This purchase agreement (together with all attachments referenced herein, collectively, the "Agreement"), made and entered into by and between Atlantic Emergency Solutions, Inc., a Virginia corporation ("Atlantic"), and Kempsville Rescue Squad, Inc. ("Customer") is effective on the last signature date set forth on the signature lines below (the "Effective Date").

**SPECIFICATIONS AND
PURCHASE DETAIL FORM**
Atlantic Emergency Solutions, Inc.
Director of Order Management
12351 Randolph Ridge Lane
Manassas, Virginia 20109
Fax (703) 257-2572

| Quantity | Chassis Type | Body Type | Price per Unit |
|----------|-----------------|----------------------|----------------|
| 1 | 2023 Ford E-450 | Wheeled Coach #3170F | \$254,630.00 |

| Drawing | UNIT-KVRS-UNIT | Scale |

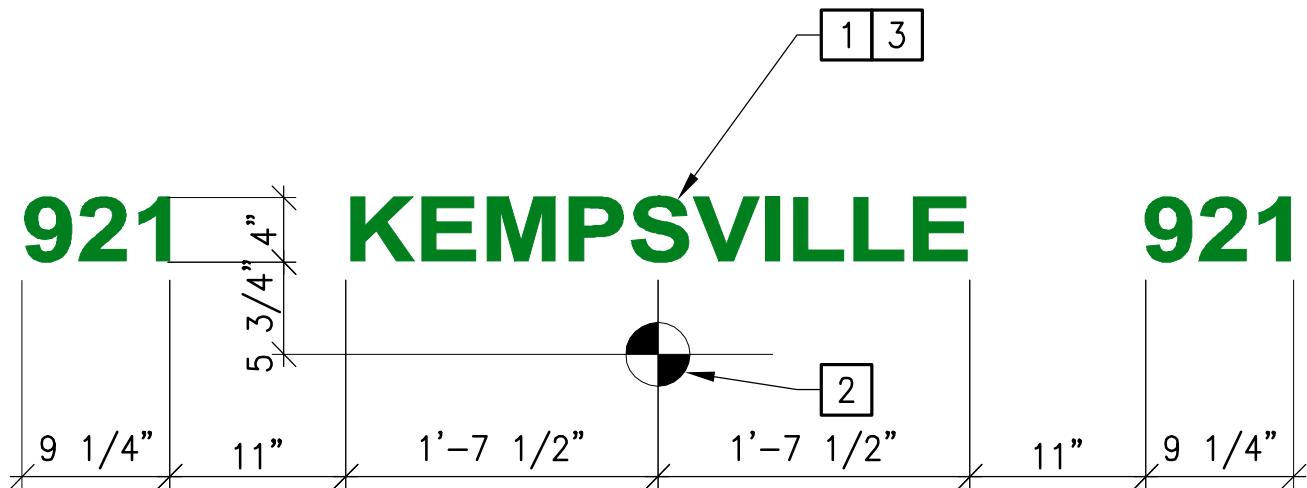
3. On Drawing AMB - REVERSE / Sheet 1, at the end of Note 1, add "NO GOLD INSETS." High contrast is desired here for traffic clearing reasons.
4. On Drawing UNIT-KVRS-UNIT / Sheet 2:

- (a) Delete the graphic word "KEMPSVILLE" and the left-most graphic unit number "921". This markup is necessary because the space formerly utilized for the deleted items will instead be used for the Cool Bar, and because having the unit number on both sides of the front of the box has been deemed overkill.

- (b) At the end of Note 1, add "NO GOLD INSETS." High contrast is desired here for Incident Management reasons.
 - (c) Replace Note 2 with "WORKING POINT IS THE APPROXIMATE CENTER OF THE CHASSIS ROOF AT THE MODULE, SUCH THAT THE UNIT NUMBER SHALL APPEAR BELOW THE LOWEST LENS MOUNTED ON THE DRIVER SIDE OF THE FRONT OF THE MODULE". This markup is necessary because the vehicle in order will include an up-high turn signal that was not present on prior KVRS vehicles.

- (d) Replace "921" with the unit number specified at graphics application time.
5. On Drawing KVRS - LATERAL / Sheet 3, pay special attention to Note 5, which requires BORDERED LETTERS, AS DEPICTED ON SHEET 17. A future version of THE PACKAGE will actually show the desired bordered letters in the graphic.

Drawing **UNIT-CONTRAST**

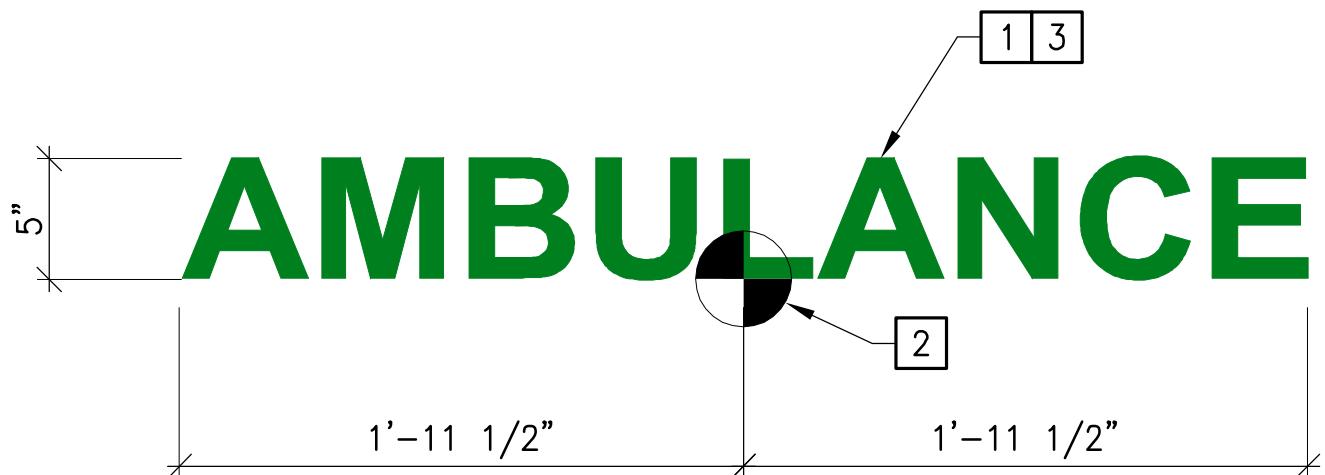
6. On Drawing UNIT-CONTRAST / Sheet 4:
 - (a) At the end of Note 1, add "NO GOLD INSETS." High contrast is desired here for Incident Management reasons.

- (b) At the end of Note 2, add "THE (WHITE) CONTRASTING COLOR FIELD SHALL BE COMPLETELY OPAQUE." This markup is necessary because a prior vehicle was delivered to KVRS with a somewhat translucent contrasting color field, which allowed a diagonal line on the backing to show through inappropriately.

Drawing **AMBULANCE**

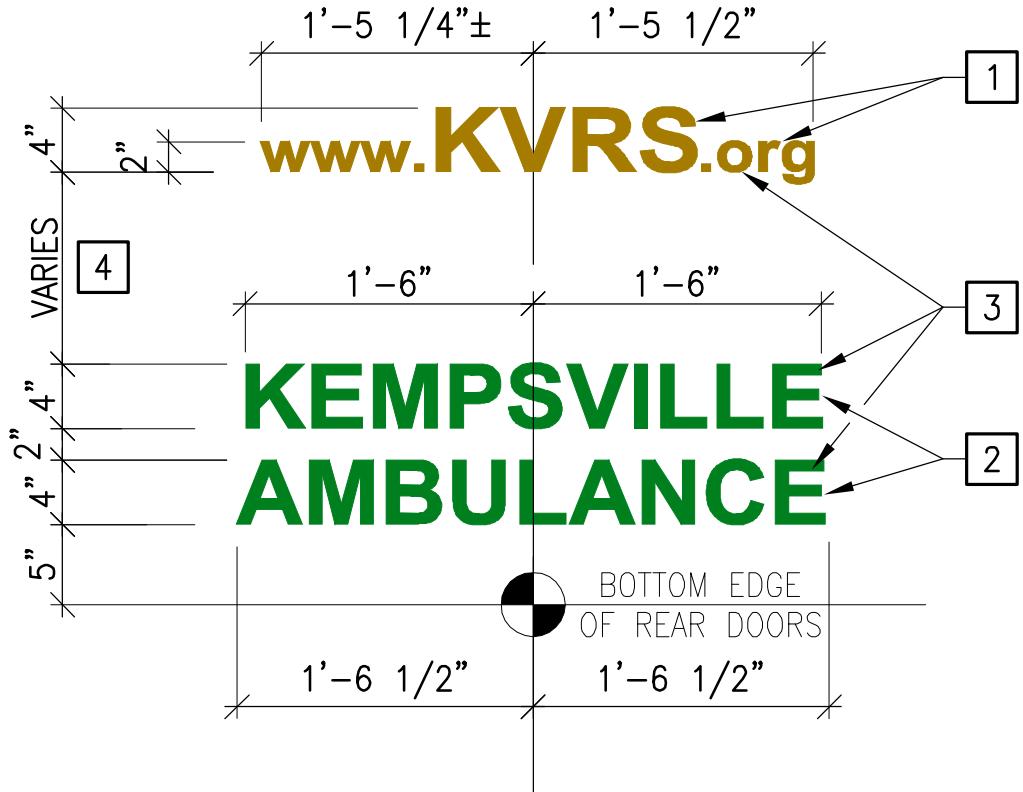
7. On Drawing AMBULANCE / Sheet 5, at the end of Note 1, add "NO GOLD INSETS." High contrast is desired here.
8. On Drawing ORG-KVRS-AMB / Sheet 6, in Note 1, change "'GOLD'" to "'GOLD' WITH 'DARK GREEN' BORDERS'. This is a new requirement, and applies only to the "www.KVRS.org" section of the graphic. A future version of THE PACKAGE will actually show the desired bordered letters in the graphic. This markup is necessary because gold-only lettering for the "www.KVRS.org" is too hard to read in some lighting situations.

Drawing **STYLIZED LOGO**

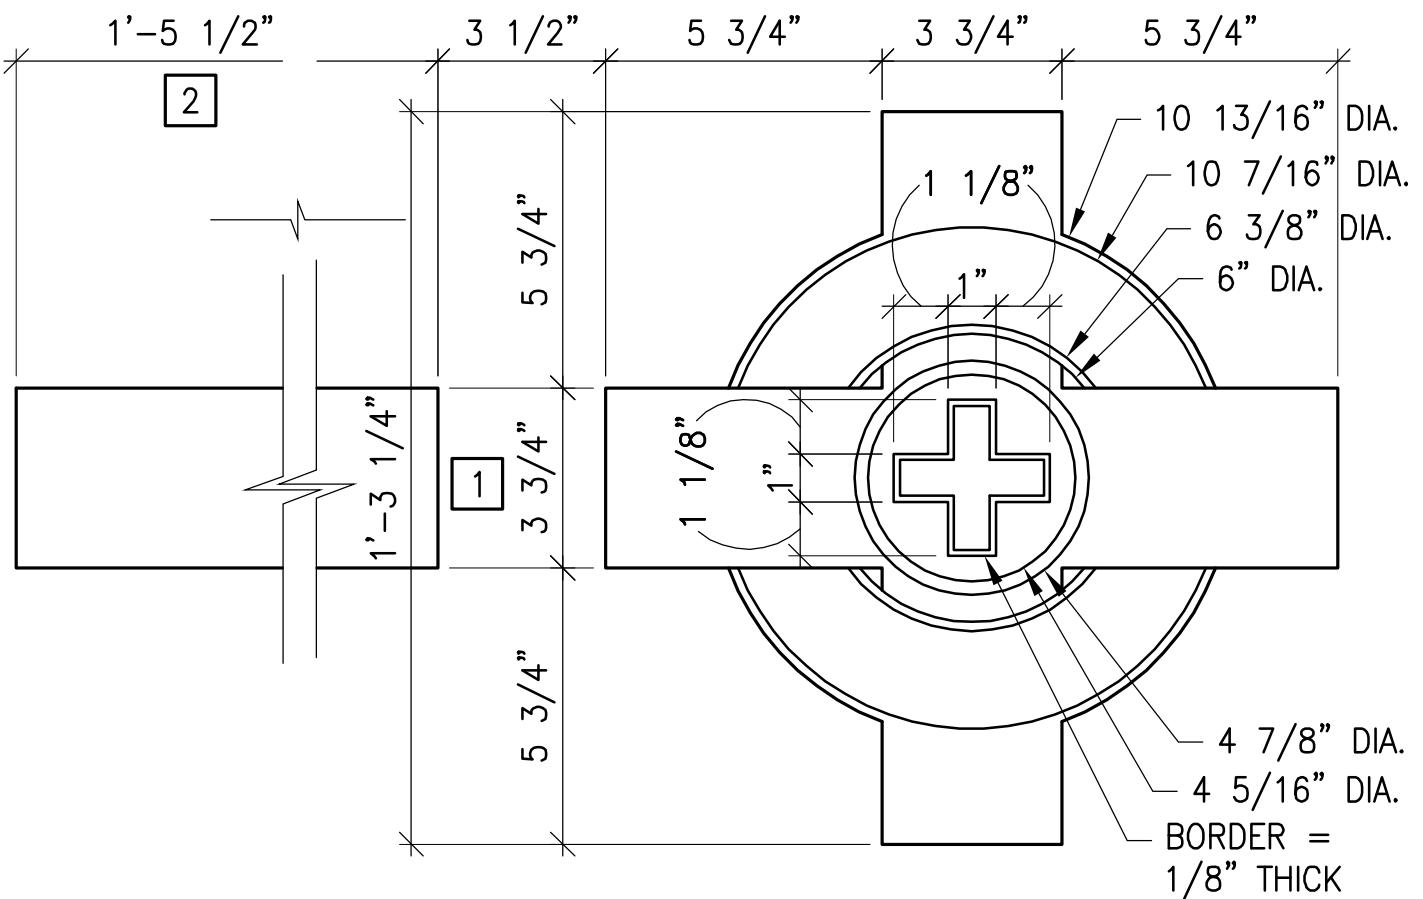
10. On Drawing STYLIZED LOGO / Sheet 8, change Note 4 to 'IF OVERALL BACKGROUND IS NOT WHITE, APPLY ADHESIVE VINYL, COLOR = "BRILLIANT WHITE".' In other words, the area referred to by Note 4 may be left void if the overall background is already white.

Drawing **UNIT-FT-REAR**

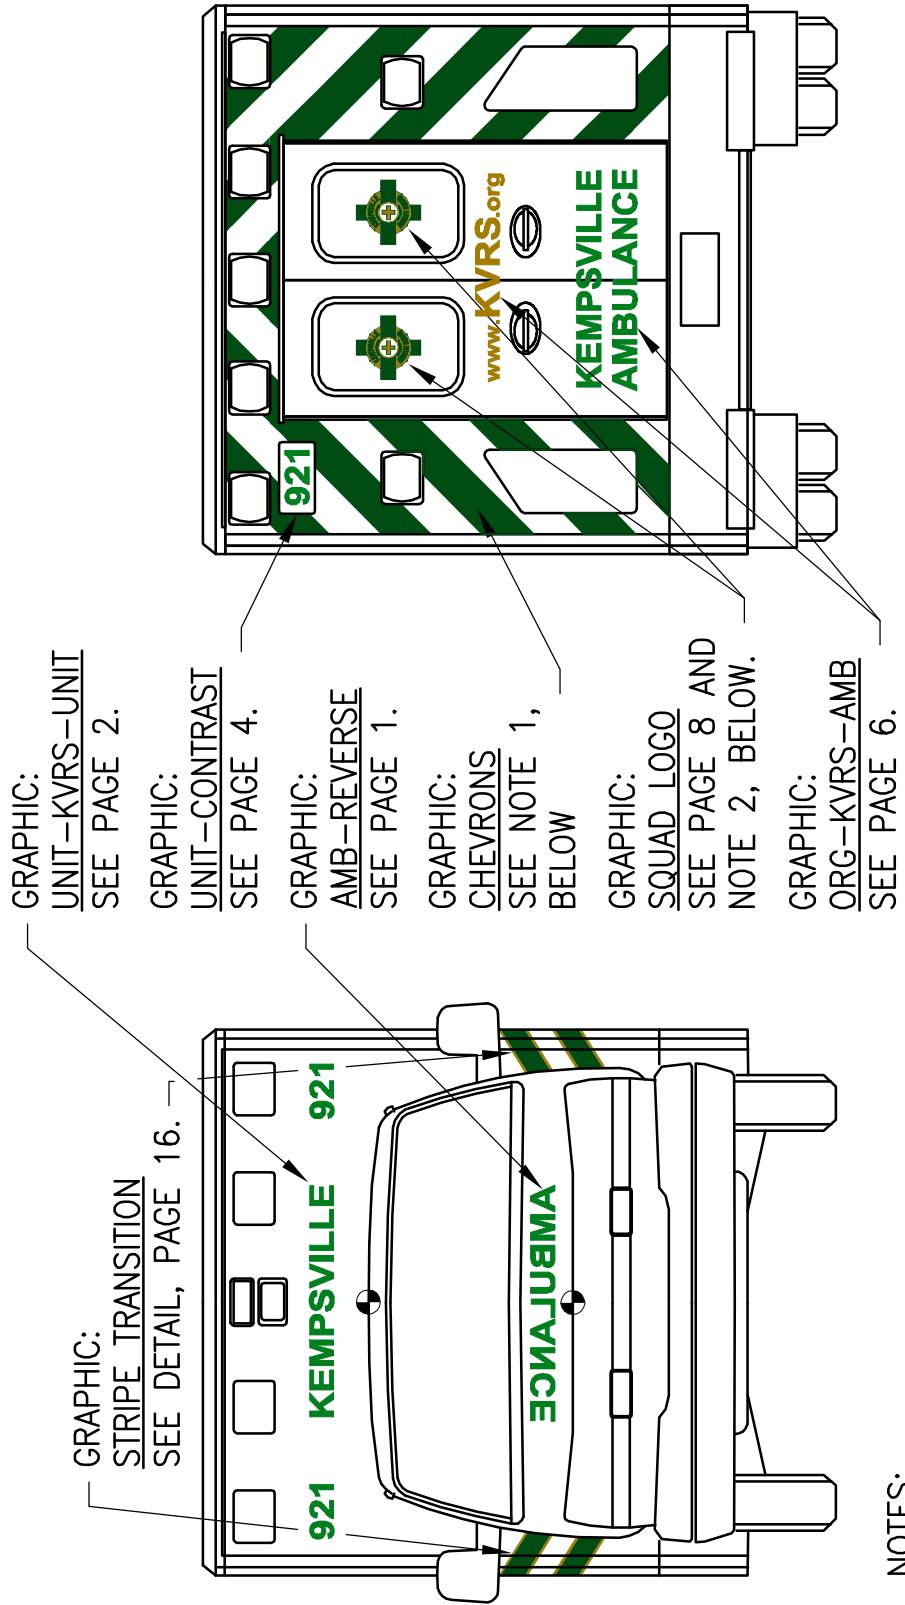
11. On Drawing UNIT-FT-REAR / Sheet 11:
- Replace all "921" markings with the unit number specified at graphics application time.
 - On the front view:
 - Delete "KEMPSVILLE" and the left-most "921" from the graphic, in accordance with item 4 (a) of this Addendum.

Drawing **UNIT-LEFT-LAT**

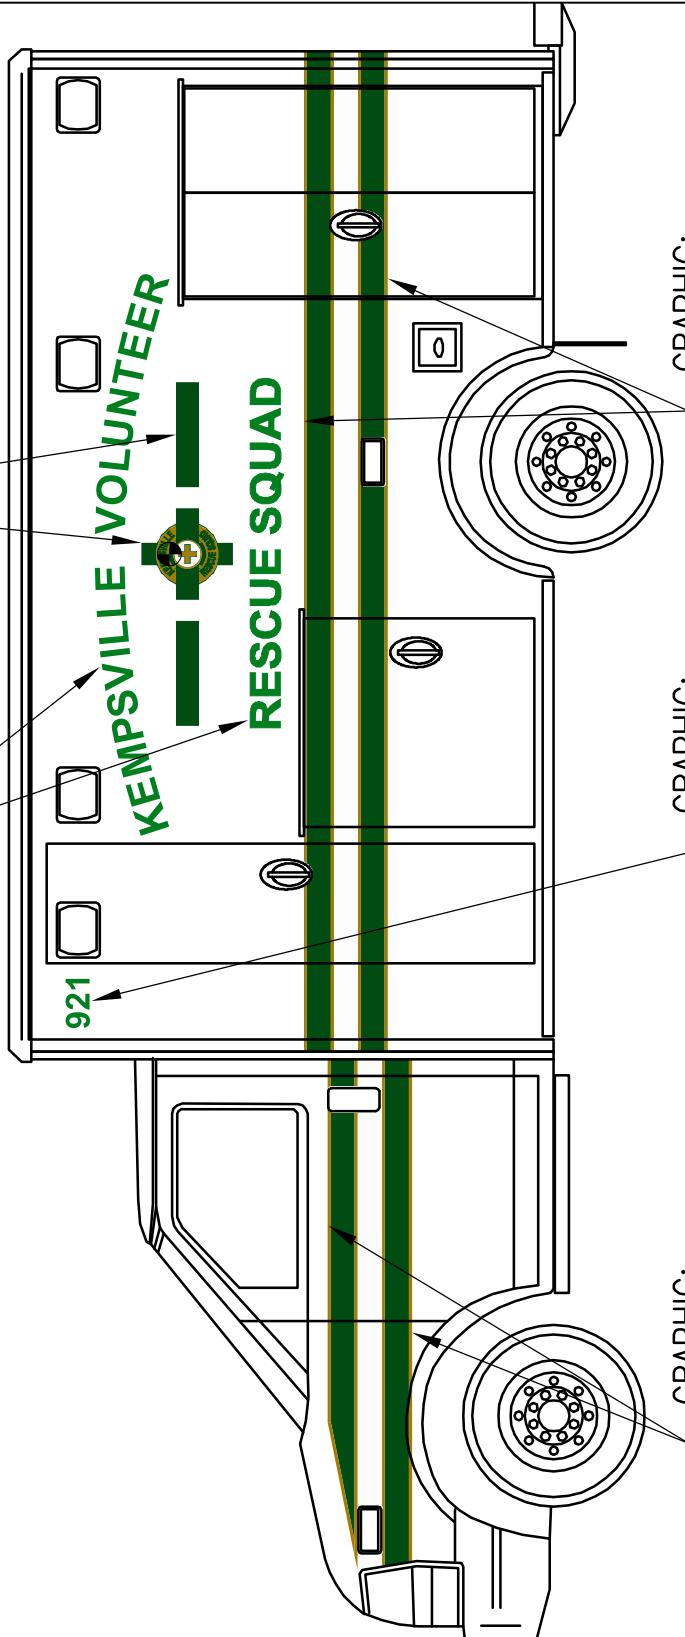
12. On drawing UNIT-LEFT-LAT / Sheet 12, use bordered lettering for the words KEMPSVILLE VOLUNTEER RESCUE SQUAD as depicted on Sheet 17. Do not use gold insets for the unit number.

UNIT-RIGHT-LAT

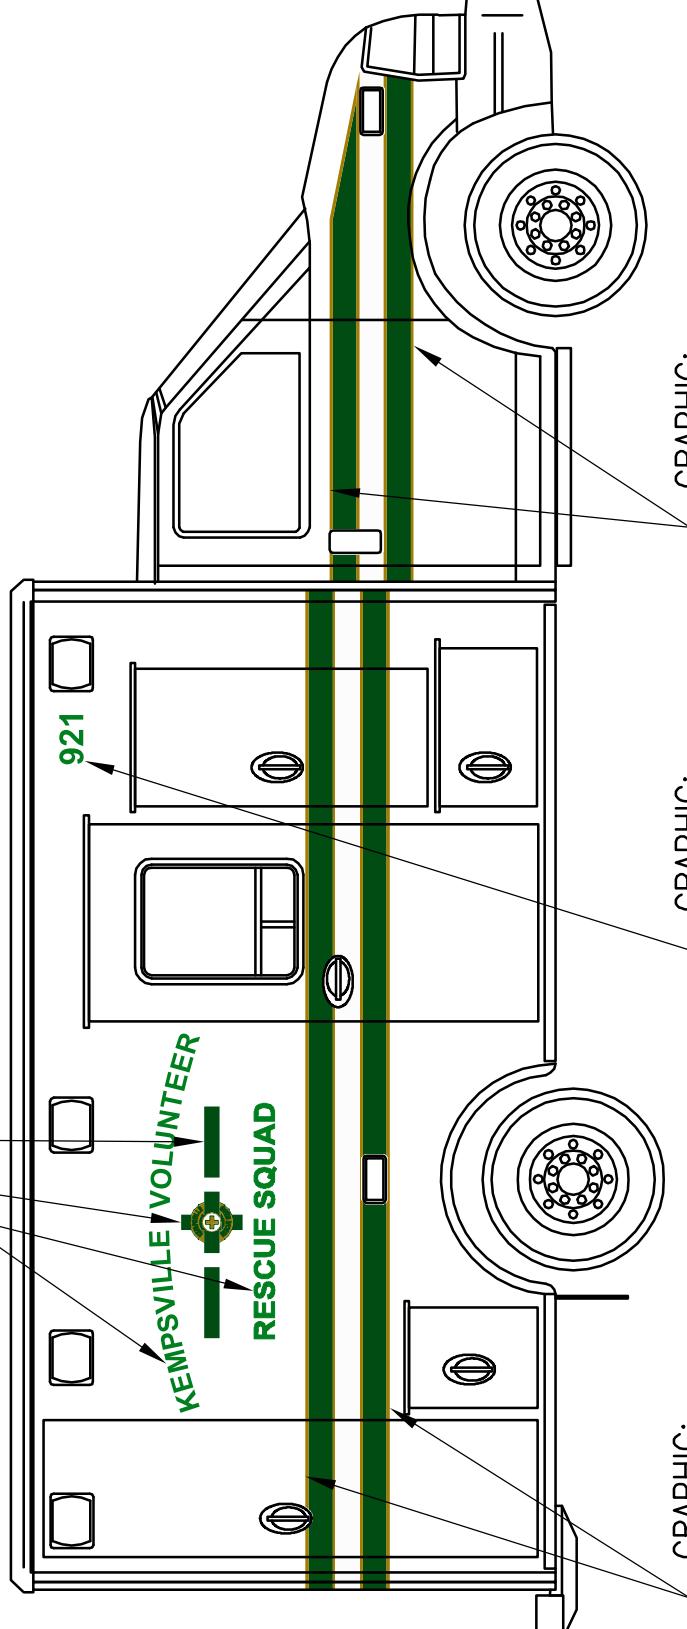
13. On drawing UNIT-RIGHT-LAT / Sheet 13, use bordered lettering for the words KEMPSVILLE VOLUNTEER RESCUE SQUAD as depicted on Sheet 17. Do not use gold insets for the unit number.

Drawing **UNIT-TOP**

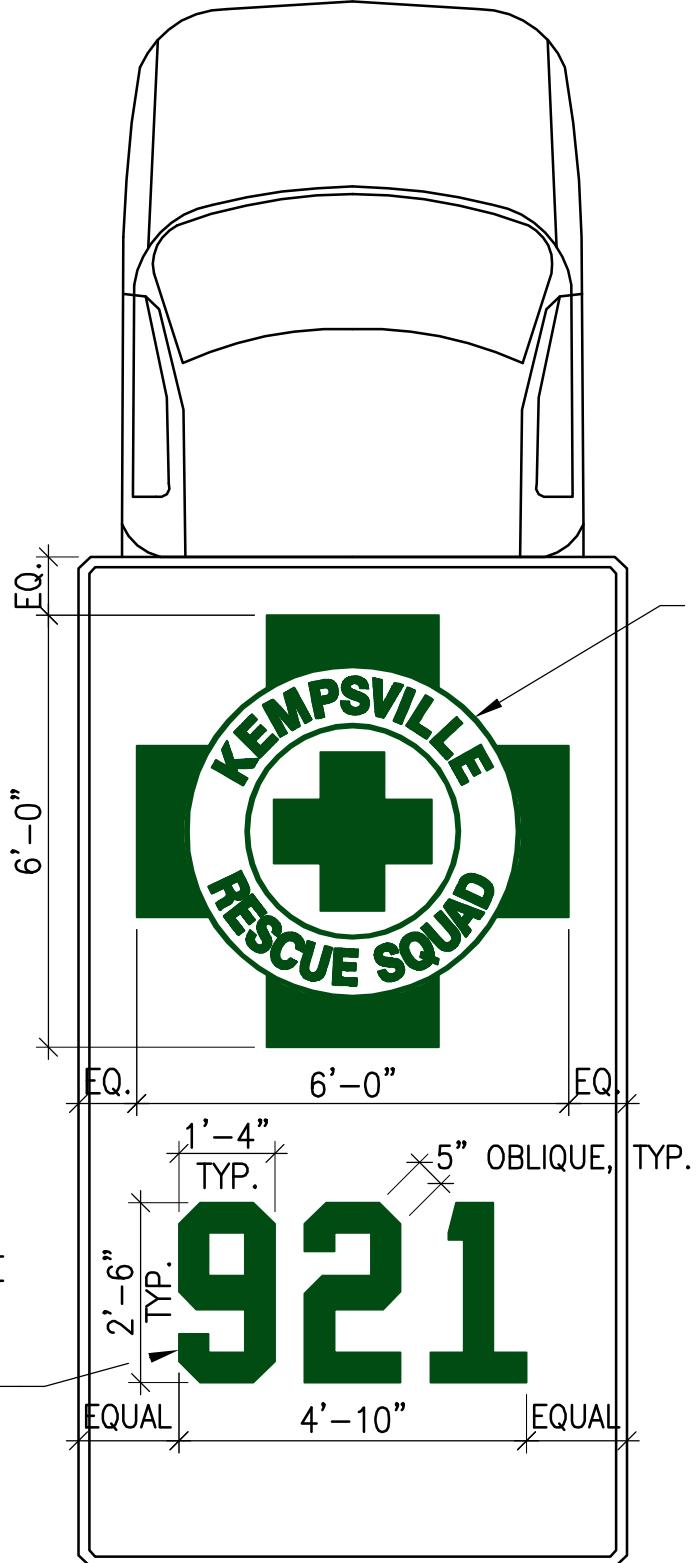
14. On Drawing UNIT-TOP / Sheet 15, note that KVRS does not require the vinyl on the roof to be a perfect match for the colors on the other parts of the vehicle. RETROreflective vinyl is required, however, for the best visibility from high altitude viewpoints, such as from aircraft or hi-rise buildings.
